## **RFQ#21-28 - ADDENDUM #3**

### **Waterloo City Hall 2nd Floor Office Space Renovation**

**ADDENDUM ISSUE DATE: August 8, 2021**

Subject: **Addendum No. 03**

EXISTING DOOR TO REMAIN. EXISTING KEYPAD IS TO BE DEACTIVATED AND REMAIN. PROVIDE NEW CARD READER.

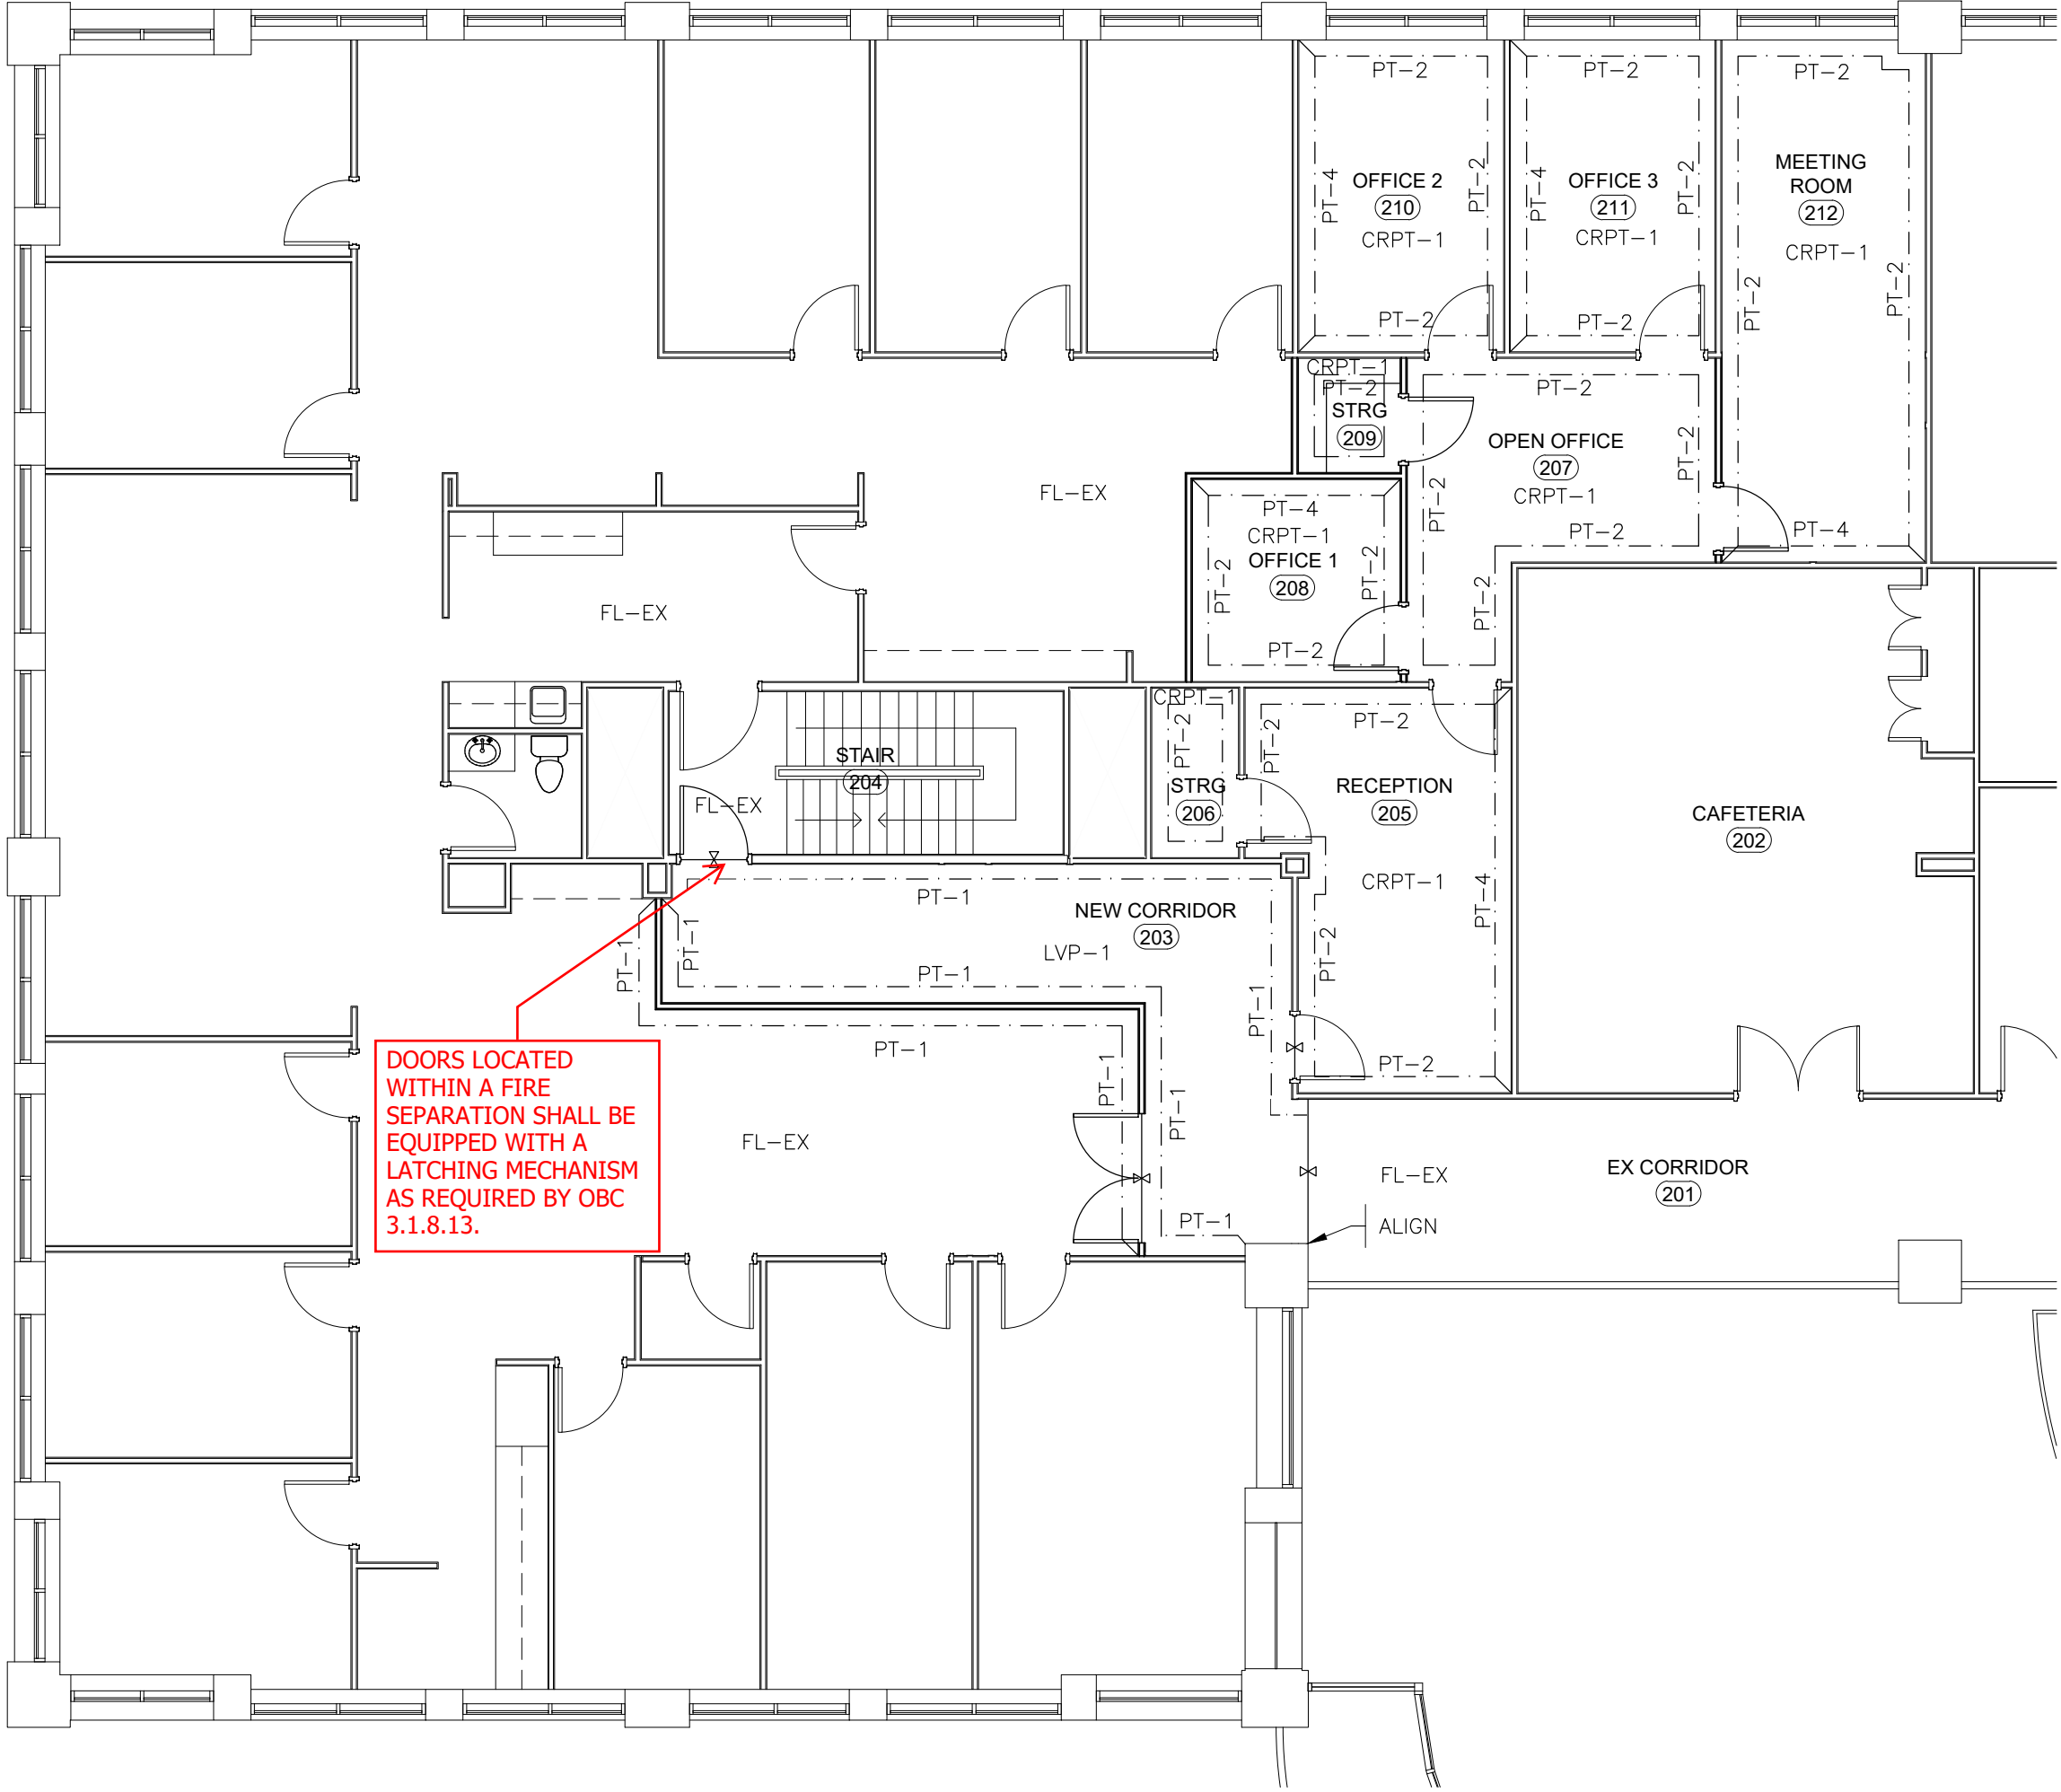
6. Contractor to include \$3,000.00 Cash Allowance for Testing to ensure smoke control and venting systems are satisfactory per OBC 3.2.8.11.(1). Refer to attached approved building permit drawings.

TESTING SHALL BE PROVIDED TO THE BUILDING INSPECTOR UPON REQUEST IN COMPLIANCE WITH 3.2.8.11.(1) TO ENSURE SMOKE CONTROL AND VENTING SYSTEMS ARE SATISFACTORY.
